**Environmental permit application EPR/YP3735YK/A001**

**to drill at Leith Hill, Surrey:**

**Response to the Environment Agency in the context**

**of relevant geology and hydrogeology**

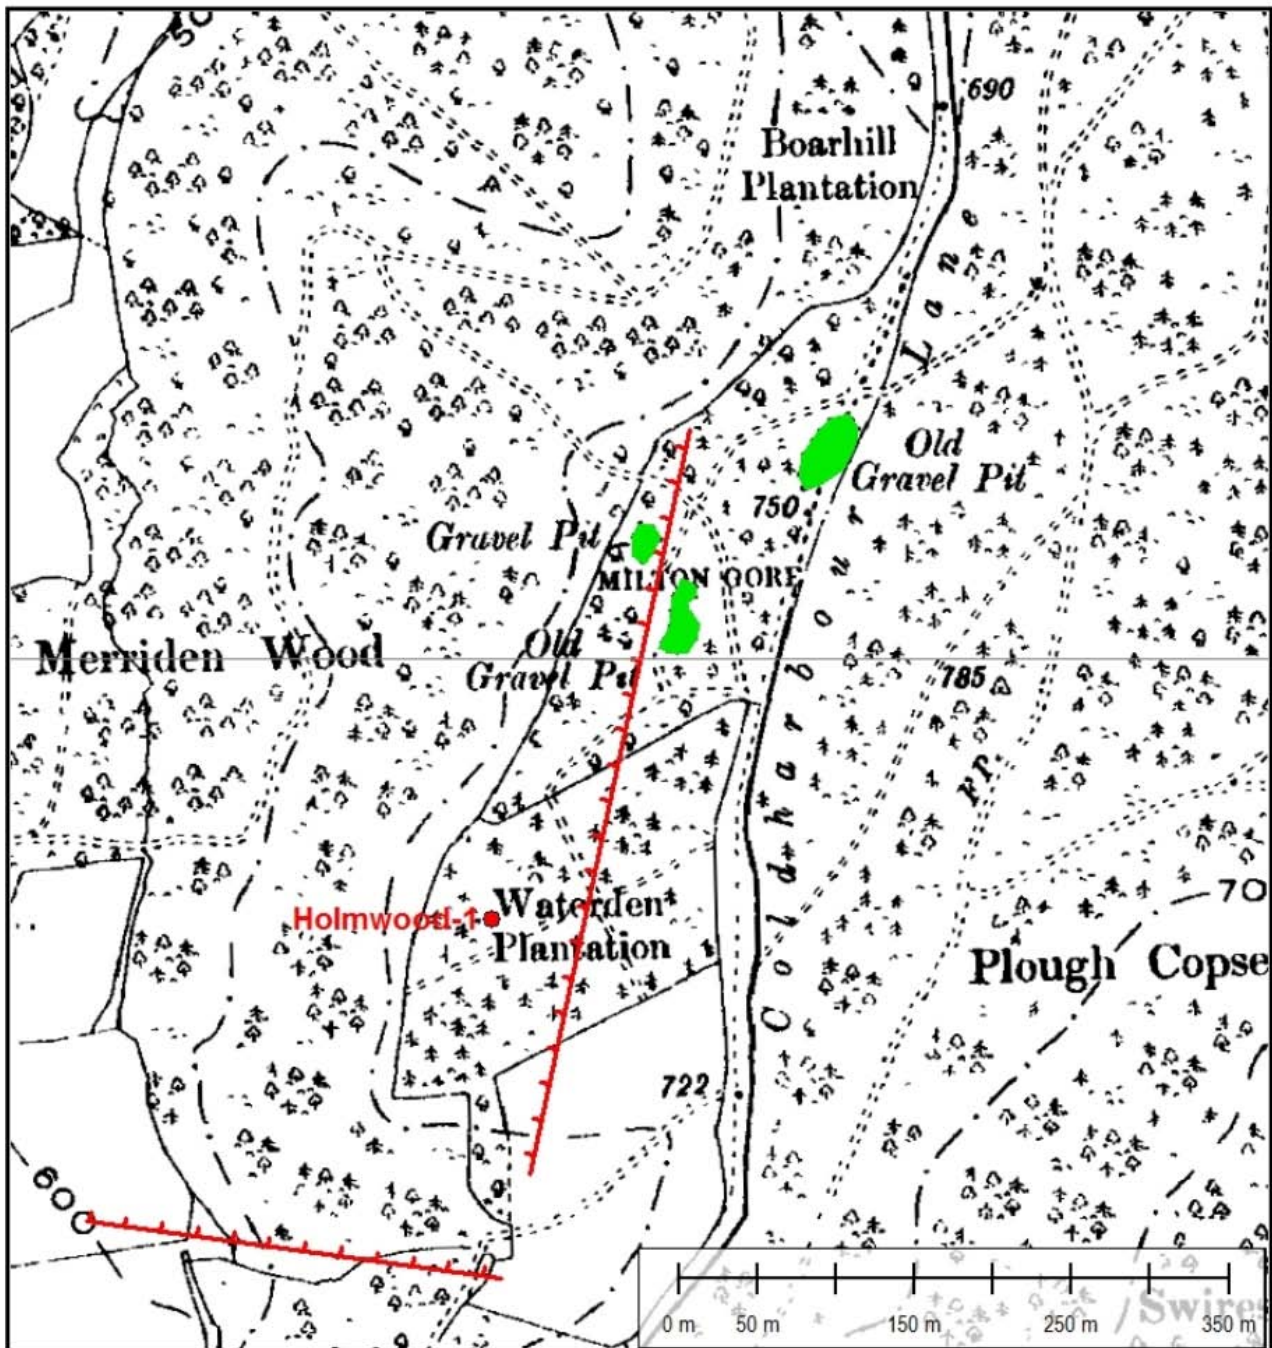
Three such quarries have been mapped on the OS historic 1:10,560 scale map made in the period of the first revision, 1888-1914. They are less visible on later editions, and the modern 1:1000 Mastermap omits them completely, presumably because they are by now overgrown and/or filled in. The historic OS map, with the quarries highlighted in green, is shown in Figure 6.8.

The early twentieth century geological field mapping, done at a time when there were many more solid rock exposures than exist today, suggests a structural complexity which has not been resolved by modern remapping. The nearly N-S trending fault may be the thrust fault referred to in the memoir. Figure 6.8 shows that it is mapped as passing within 50 m of the wellsite.

In view of the evident unresolved complexity of the shallow geological structure, it is incumbent on the Applicant to resolve the uncertainties around the wellsite. This could be achieved by commissioning the BGS to re-examine the historical evidence, to re-open old quarries, and/or conduct trenching excavations across the areas of suspected faults.

*Figure 7.1. Annotated version of Dusseault et al. (2014) fig. 3.4, showing excentric casing in a deviated wellbore. Cement is shown in brown, casing in black.*

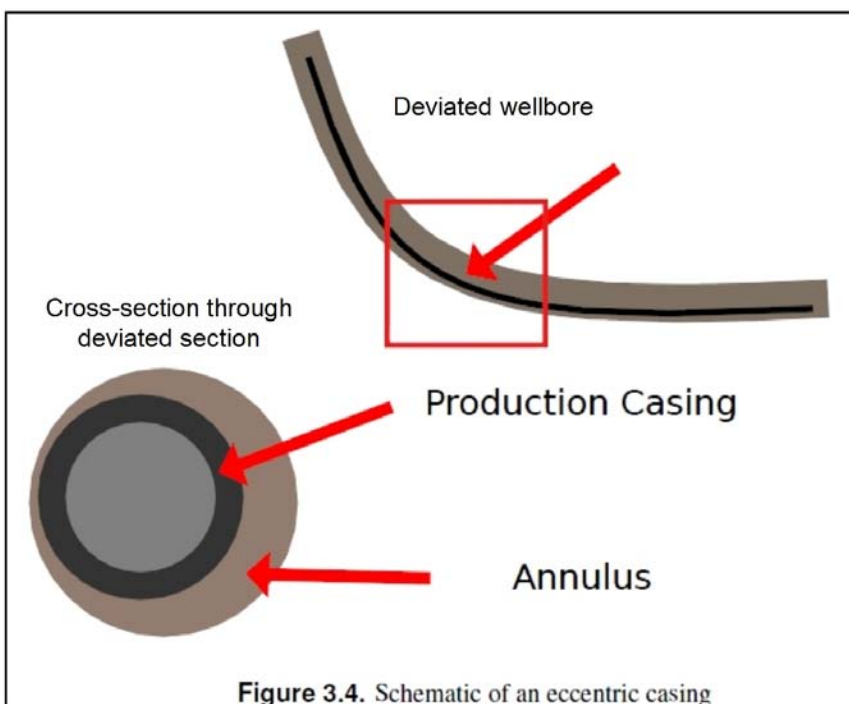
There is a large literature discussing this problem. The Applicant has not provided any evidence that it understands this problem, nor how it proposes to deal with it.
